## SOUTHEASTERN OAKS TOWNHOMES

Revised Post SETDRC

**Updated:** June 4, 2014

Specific Parcel Master Plan (SPMP) approval for the Southeastern Oaks Townhome residential development. The project is comprised of 140 residential units.

# DEVELOPMENT PLAN TOWNHOME DETAIL

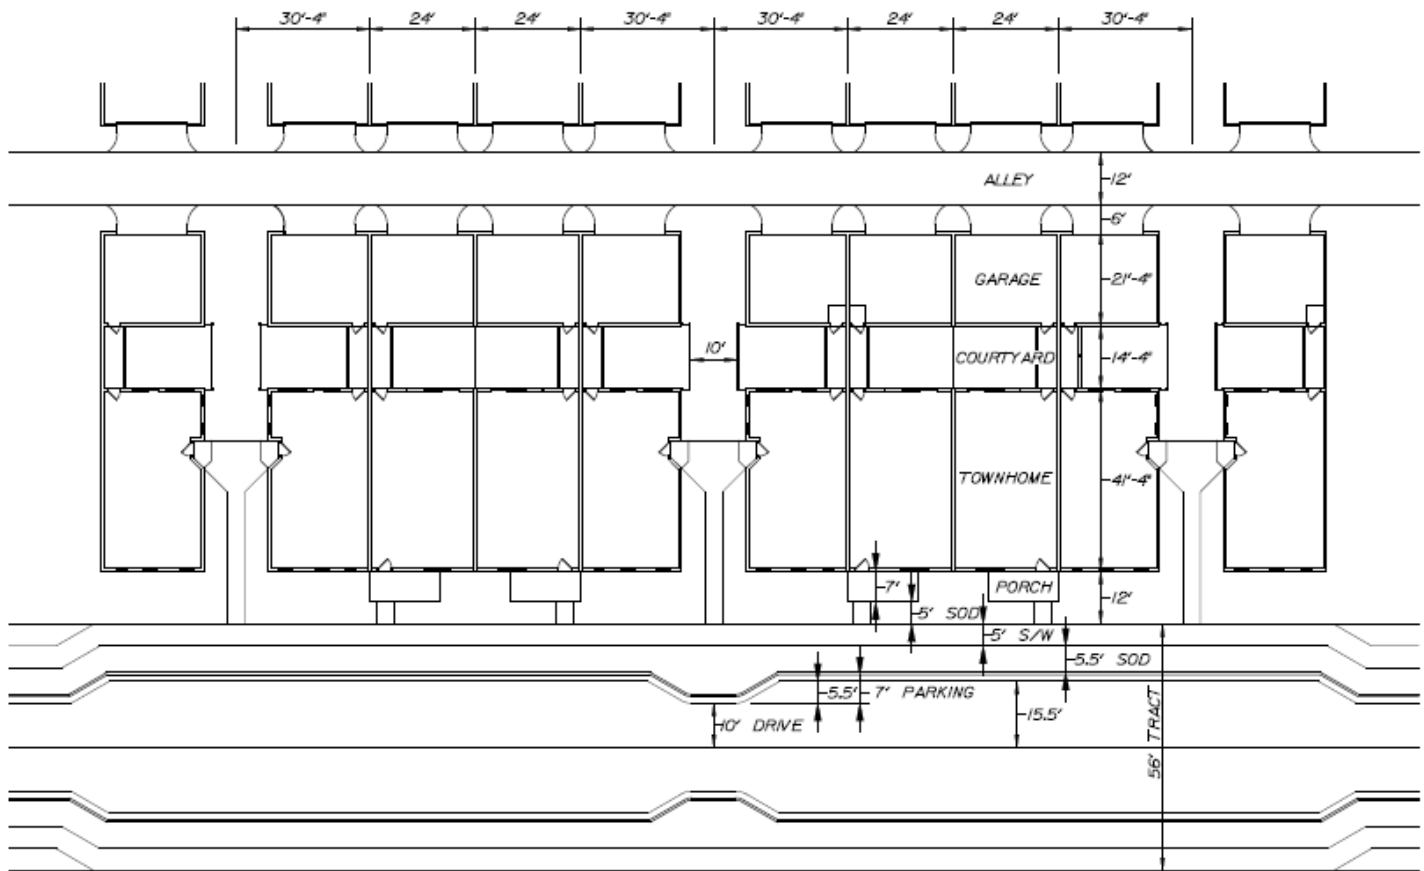
According to the PD, the street side yard setback is required to be 15 feet. However, the SPMP depicts a street side yard setback of 10 feet. The SPMP shall be revised to meet the PD requirement of 15 feet for the street side yard setback.

Street Side Yard Setback—The applicant shall revise the plan shall to depict the required 15 feet street side yard setback.

# ELEVATIONS

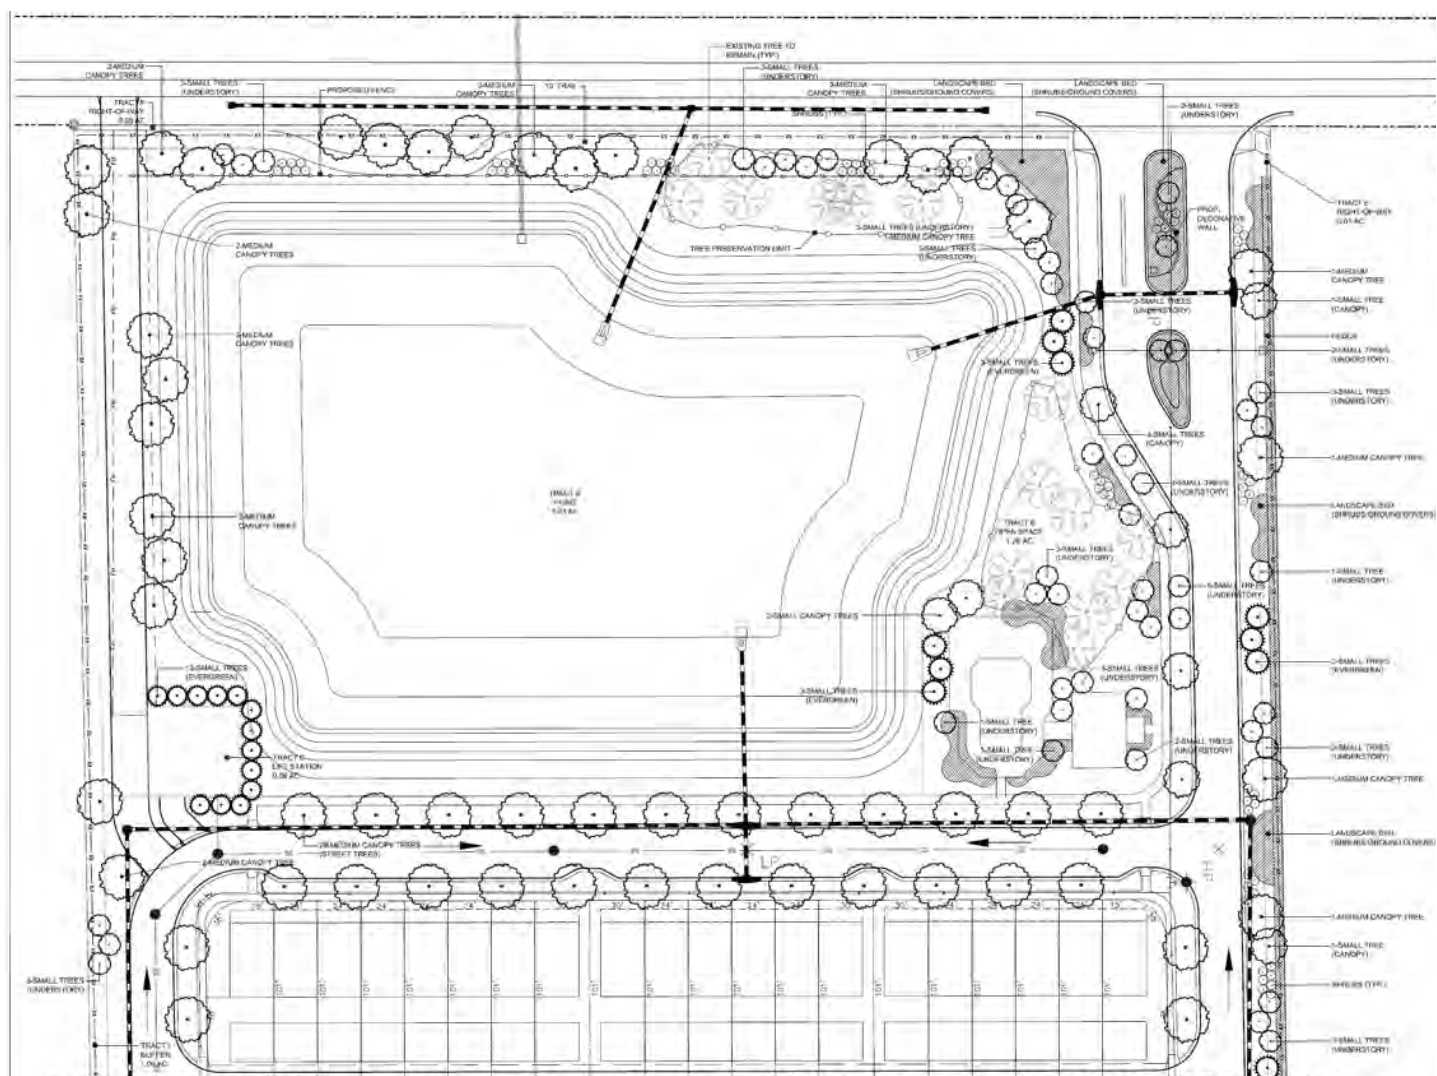
LDC Section 68.302 requires each development of 100 or more homes to provide at least 4 models with 3 elevations each. Given that the units are attached, this project shall include at least 3 sets of building elevations, which are subject to Appearance Review. The models shown on pages 10 & 11 were submitted after the SETDRC meeting and meet this requirement.

## LANDSCAPE PLAN

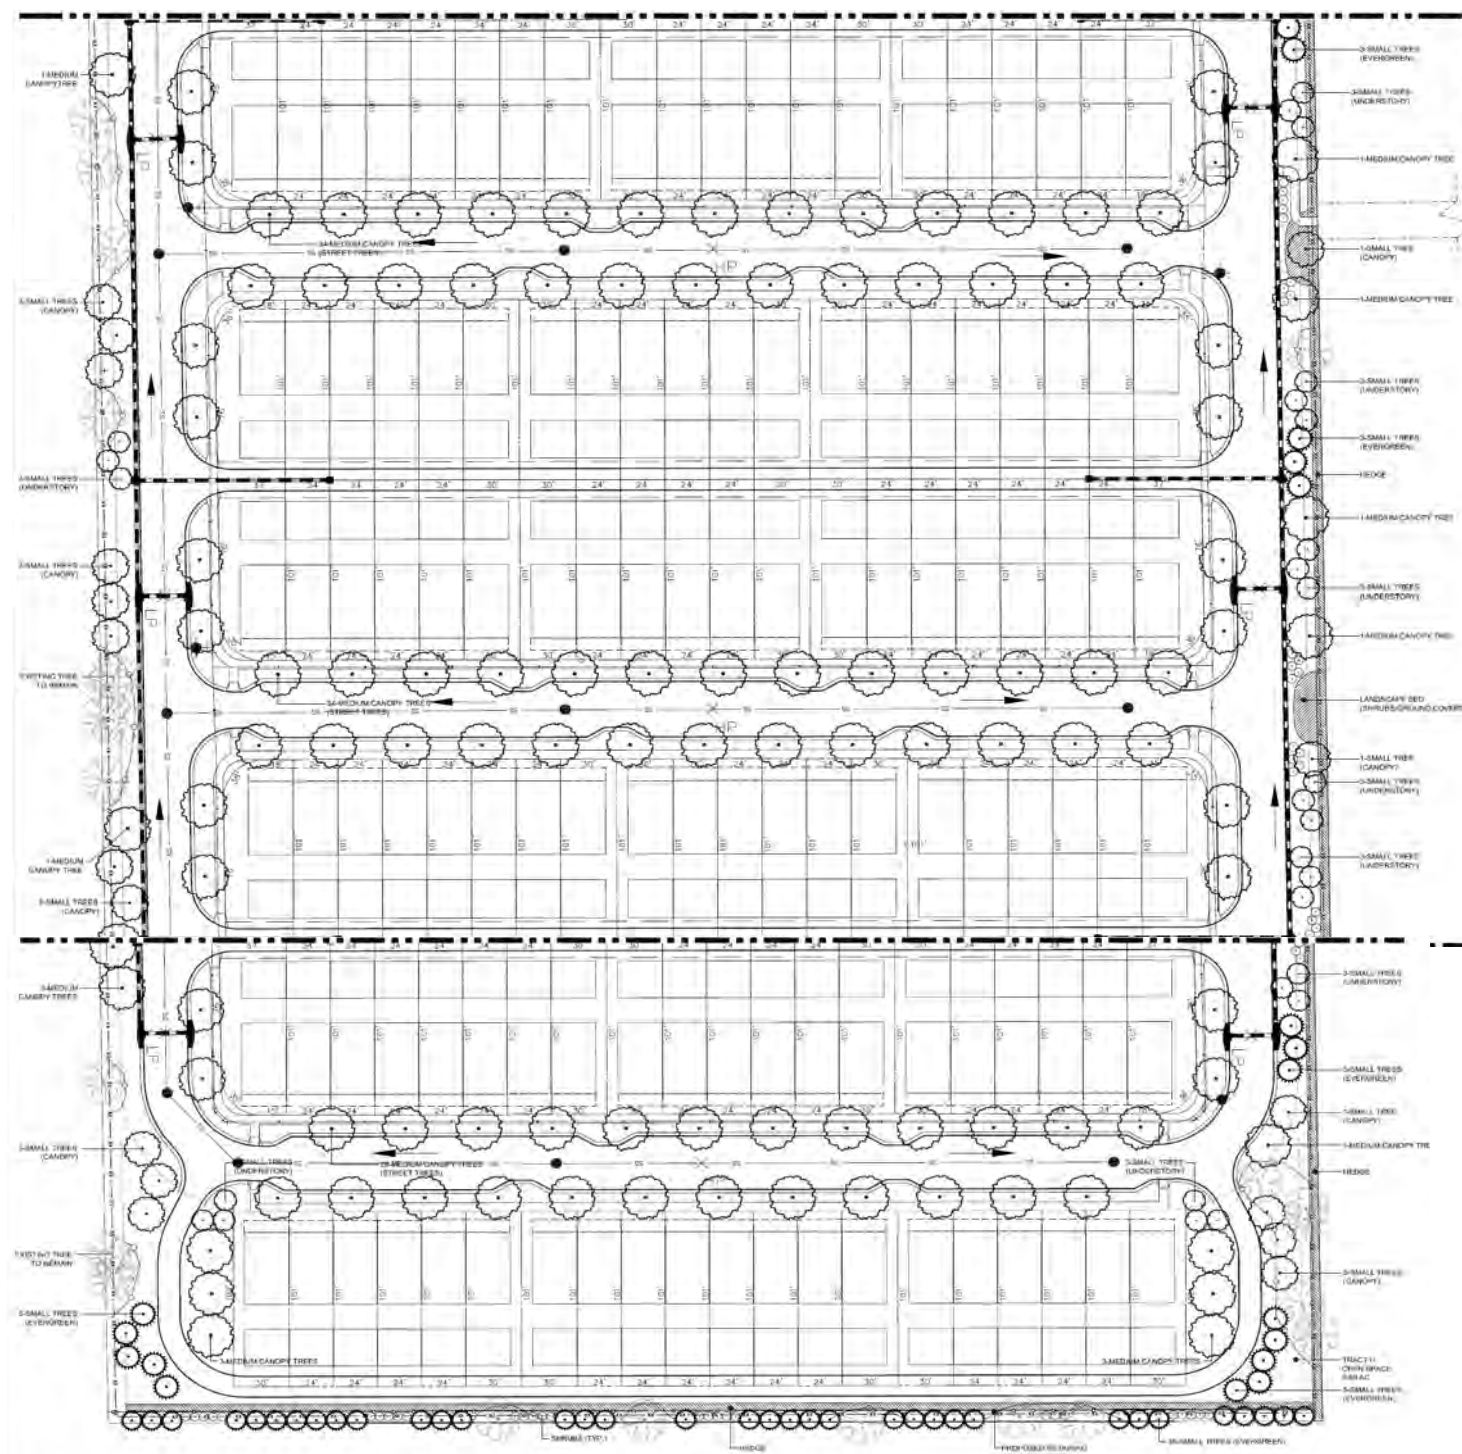
The applicant submitted a landscape plan with this application. The landscape plan can be found on pages 17 and 18. The landscape plan shall be developed in accordance with Chapter 60 Part 2 of the LDC. Individual lots will be reviewed at the time of building permit submittal. Street trees adjacent to townhome lots may be installed concurrent with the home’s landscaping. Street trees adjacent to common areas shall be installed concurrent with the infrastructure.

The landscape plan shall be developed in accordance with Chapter 60 Part 2 of the LDC. Individual lots will be reviewed at the time of building permit submittal. Street trees adjacent to townhome lots may be installed concurrent with the home's landscaping. Street trees adjacent to common areas shall be installed concurrent with the infrastructure.

The landscaping and hardscape plan shall be revised to show the pedestrian gate connection consistent with the Phase 2 approval.

# ROAD CROSS SECTIONS

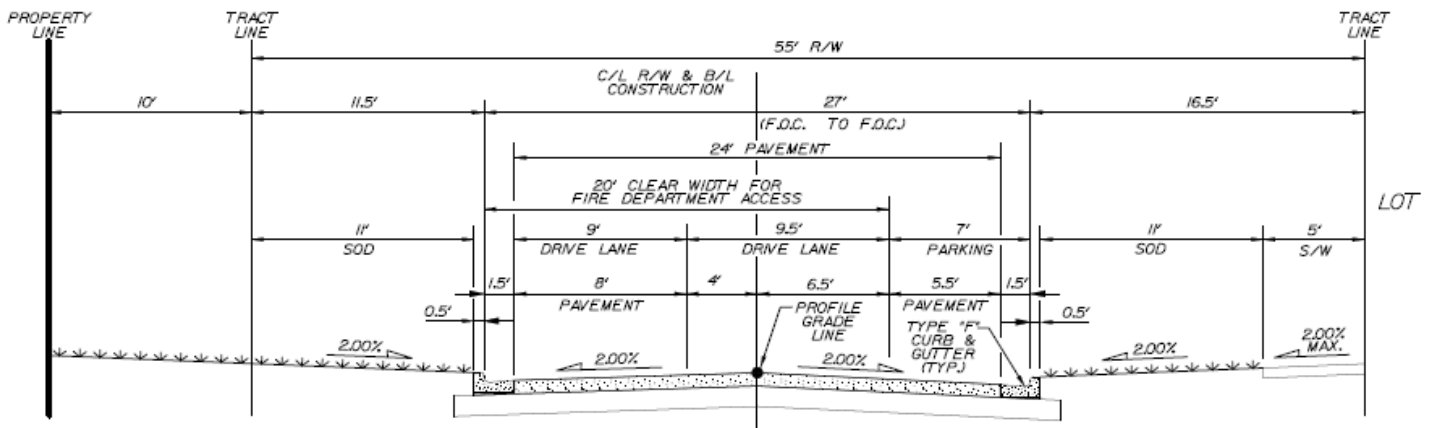
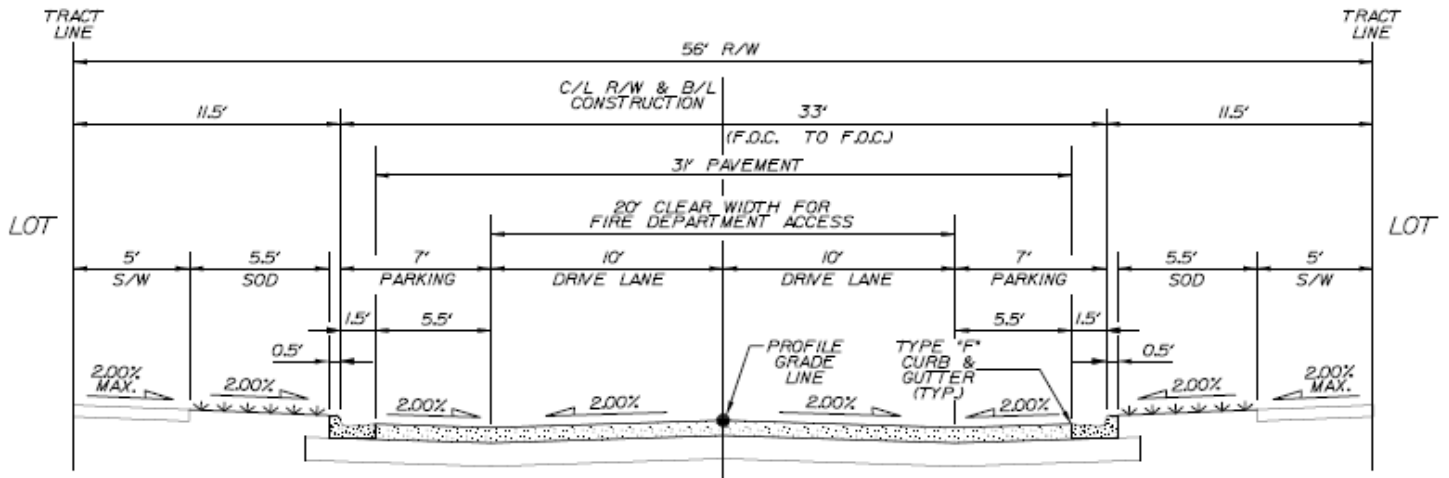
Alleys will have an inverted crown.

- On-street parking width shall be 7' wide.
- All alley cross sections must provide sufficient pavement width for fire apparatus and solid waste vehicles.
- Additional emergency access is required for the development.
- All interior roads shall be private and labeled as such.
- A 42 inch to 72 inch high metal picket fence will be required at southern alley due to the change in grade elevations.
- A minimum 10' wide drive aisle on local streets is required; gutter cannot be counted in this width.
- Provide on plat that interior roads will be private.
- Interior road cross sections may need to be adjusted based on Fire Department requirements. An Auto-Turn exhibit will be required that depicts fire apparatus will have the ability to access detached garages at the south end of the project.
- Alleys will have an inverted crown.
